Title:	Husky 3 Foam Pump – GEN 1 Pump Discontinued			
Number:	SB_446.1	Release Date:	06/24/2019	
Revision Number:	1	Revision Date:	04/18/2022	
Chassis Type:	All chassis types			
Component Description:	Husky 3 Foam pump redesign, Gen 1 to Gen 2			
Warranty:	Not Applicable			
Parts:	*Discontinued* GEN 1 Husky pump (Pierce p/n 2851584) GEN 2 Husky pump (Pierce p/n 3267102) GEN 1 to GEN 2 Conversion kit (Pierce p/n 3411256)			
Tools:	n/a

SERVICE BULLETIN #446.1

Figure 1

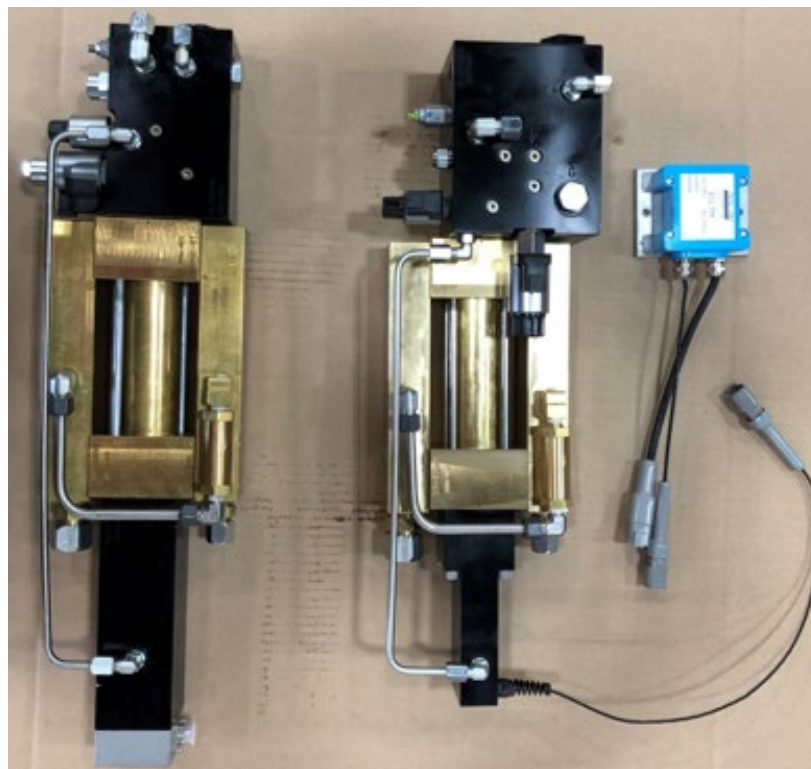
The discontinued GEN 1 Husky 3 pump (Pierce p/n 2851584) uses a blue box signal conditioner for the position transducer in the foam pump. The GEN 2 Husky 3 pump (Pierce p/n 3267102) uses a transducer that does not require a signal conditioner. (See Figure 1)

In the event you need to replace a GEN 1 pump, a conversion kit is available which includes the GEN 2 pump and two harnesses which will allow a direct install.

- Discontinued Pump = GEN 1 Husky 3 pump (Pierce p/n 2851584)
- New Pump = GEN 2 Husky 3 Pump (Pierce p/n 3267102)
- Conversion kit from GEN 1 to GEN 2 Husky 3 Pump (Pierce p/n 3411256)
 - 1pc GEN 2 Husky 3 Pump (Pierce p/n 3267102)
 - 1pc Linear Feedback Sensor Adaptor Harness (Pierce p/n 3599440)
 - 1pc Signal Conditioner Delete Adaptor Harness (Pierce p/n 3599442)
